Addendum #01

Project Name: Proposed Renovation and Addition: Ellisville City Hall and Police Station

Project Number: 20016

Date: 2023-03-17

B1 LIFE SAFETY LEVEL 1 FLOOR PLAN
1/8" = 1'-0"

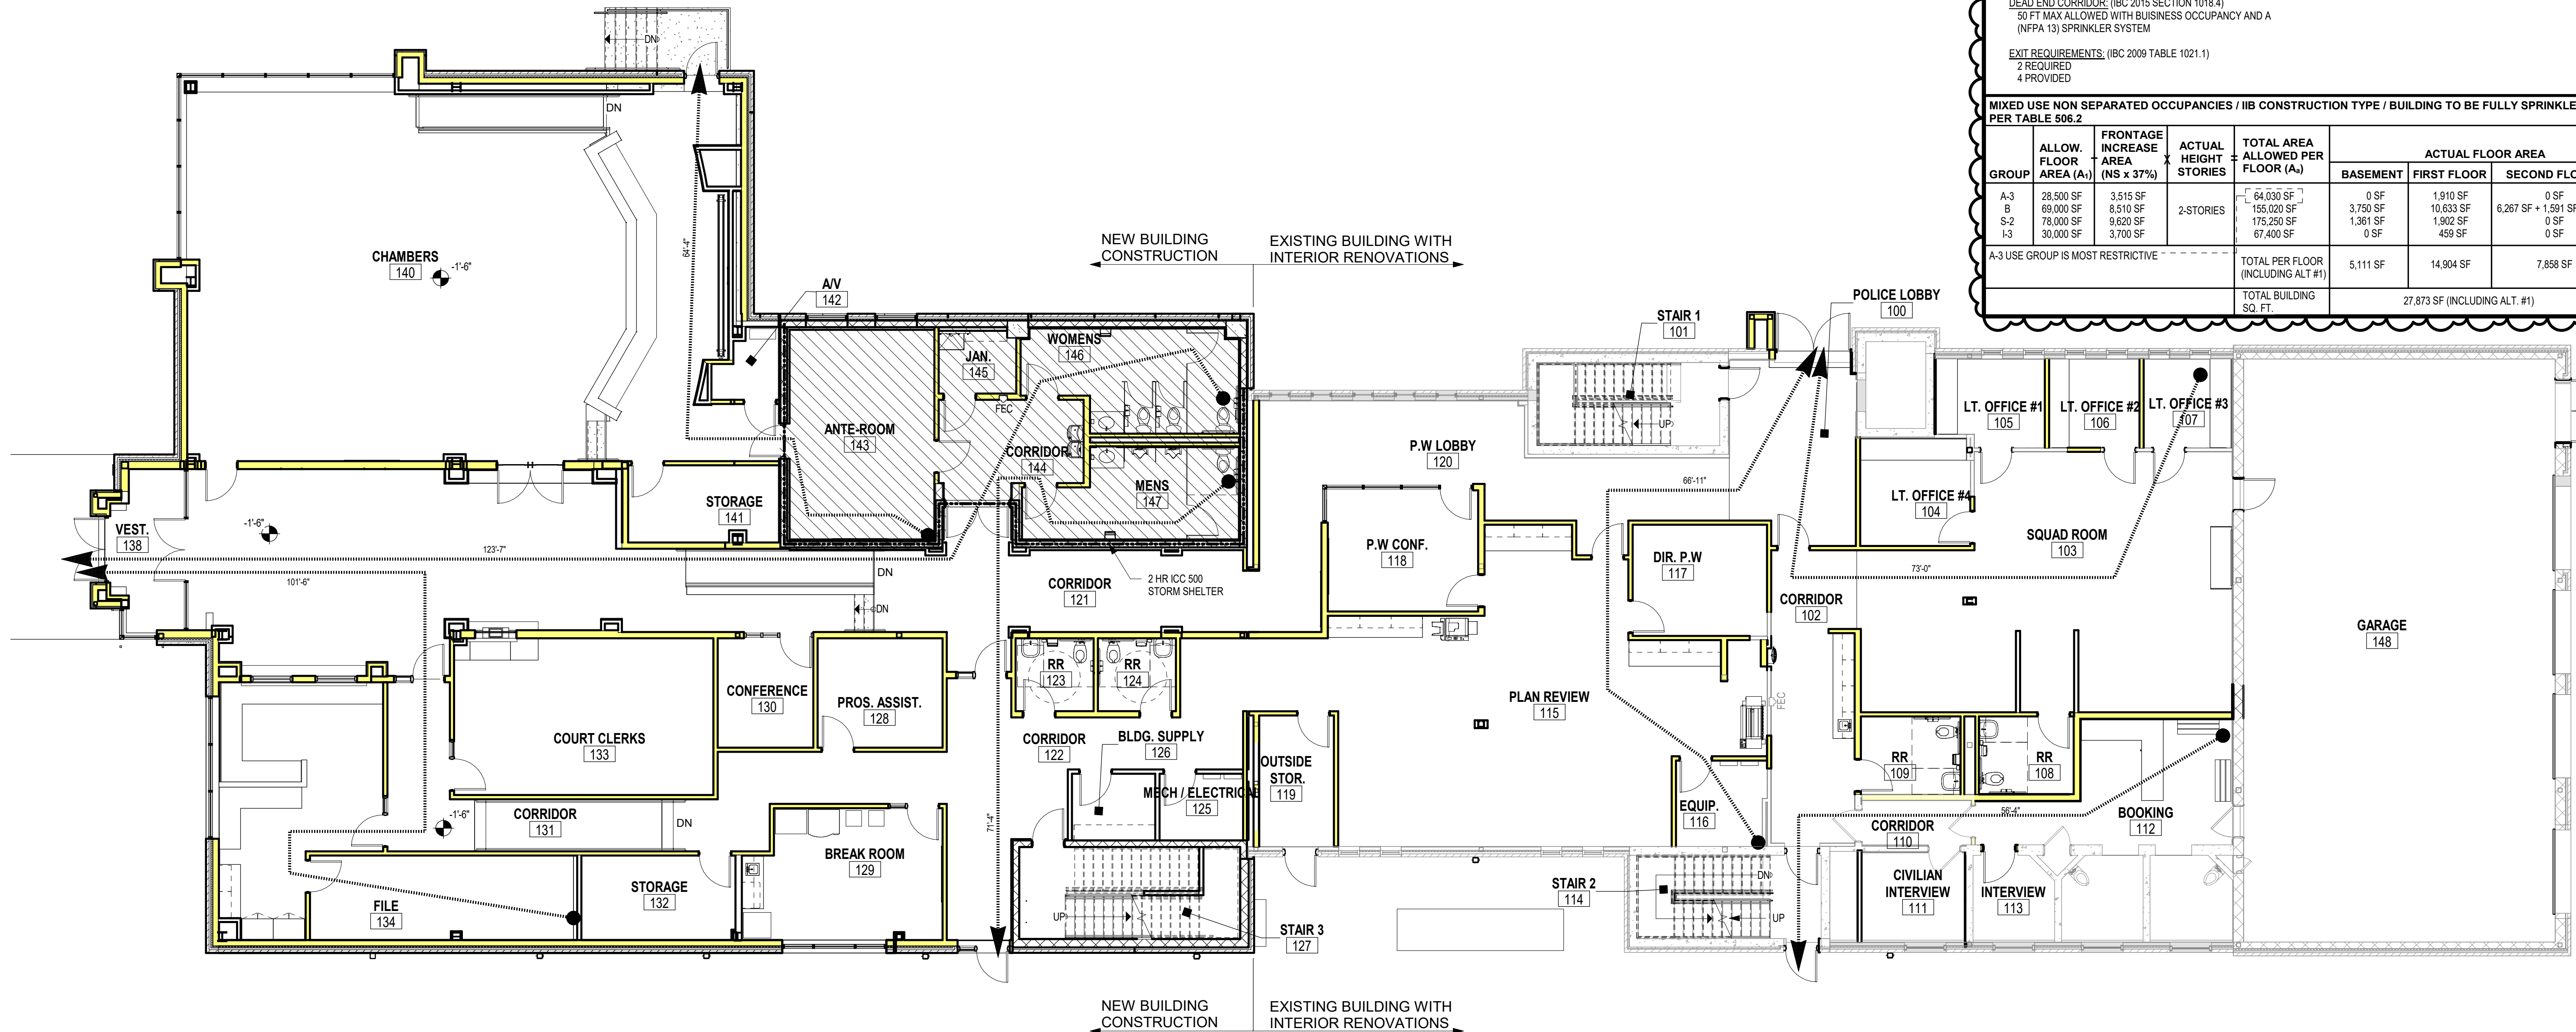
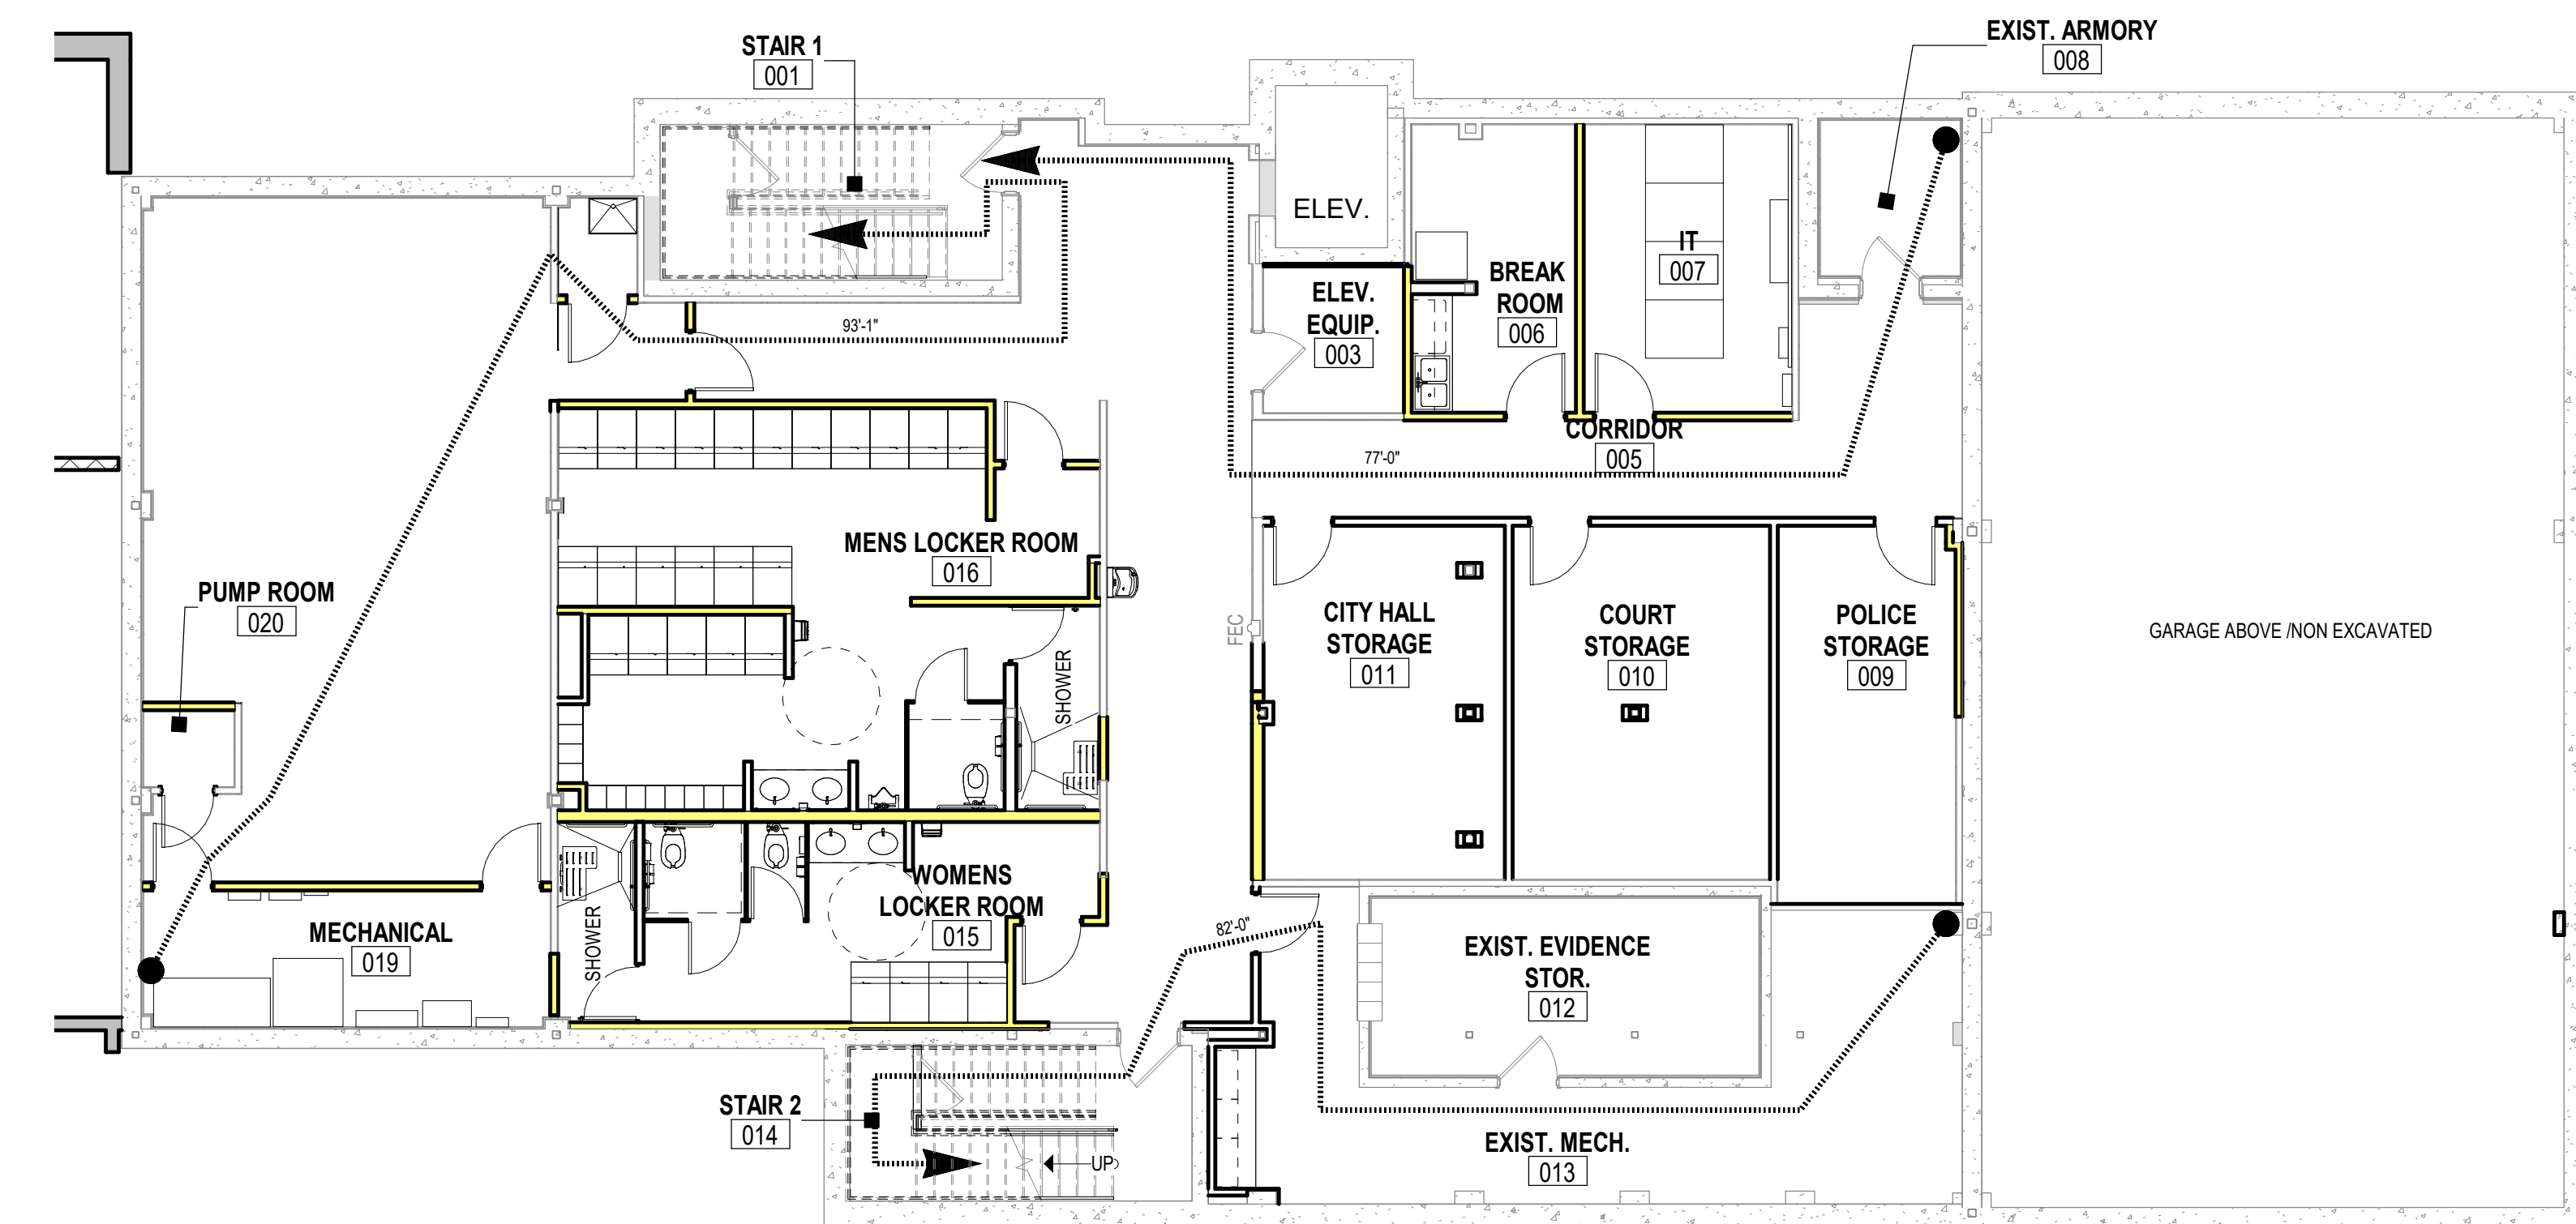
1. Sheet G-002: Life Safety-Basement and Level 1
 - a. **Revised Building Code information.**
 - b. **Reference attached Revised Sheet.**
2. Sheet A102D: Lobby Clerestory Plan and Reflected Ceiling Plan
